AGENDA

July 21, 2011 Standards Committee Meeting

RE: Agenda for the July 21, 2011 Standards Committee Meeting

805-TSCS-01 TRAFFIC SIGNAL CANTILEVER STRUCTURE SIGNAL ARM DIMENSIONS & DETAILS

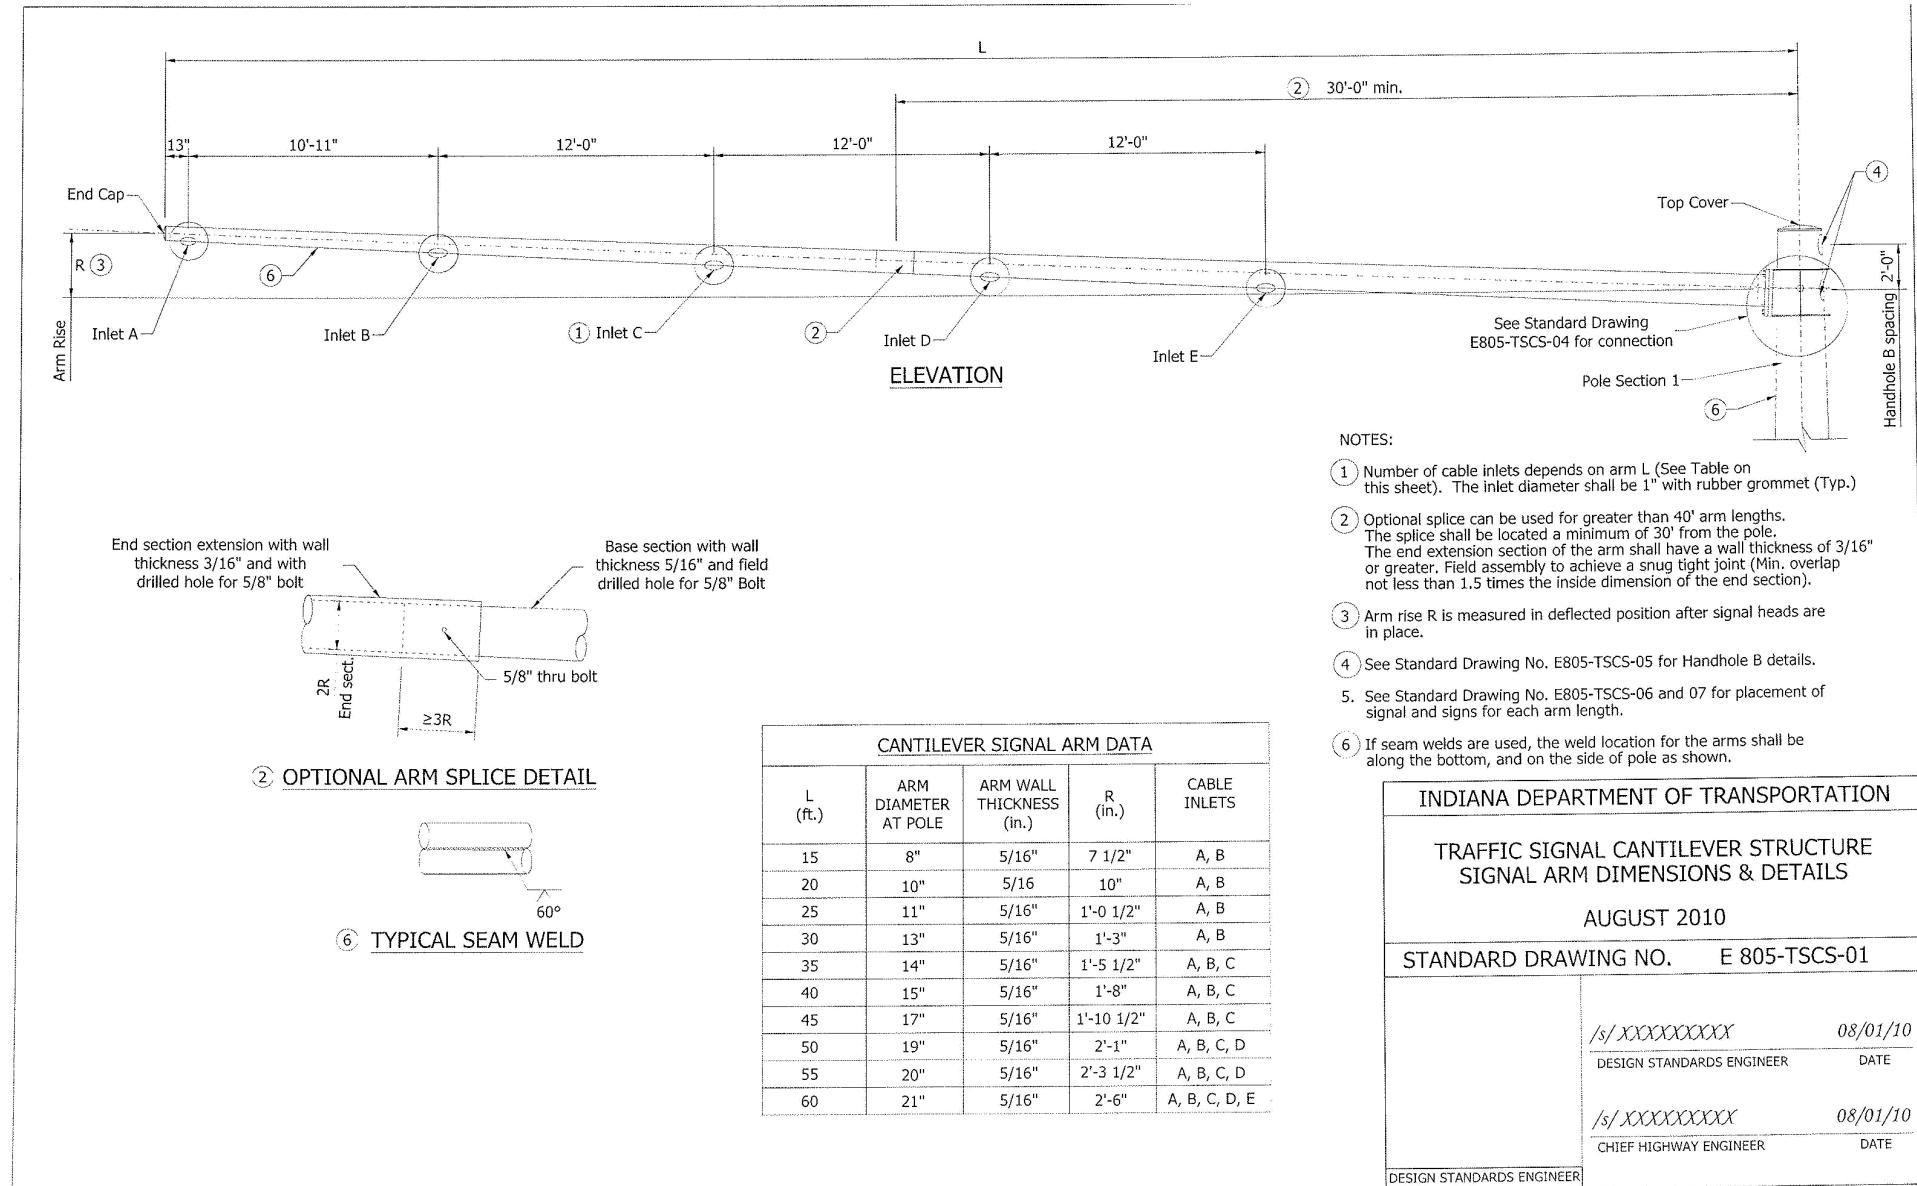
PROBLEM(S) ENCOUNTERED: Existing Signal Mast Arm standard drawings doesn't meet the latest AASHTO code requirements.

PROPOSED SOLUTION: New Signal Cantilever Structures and foundation standard drawings were developed meeting the latest AASHTO code (2009 fifth edition) requirements.
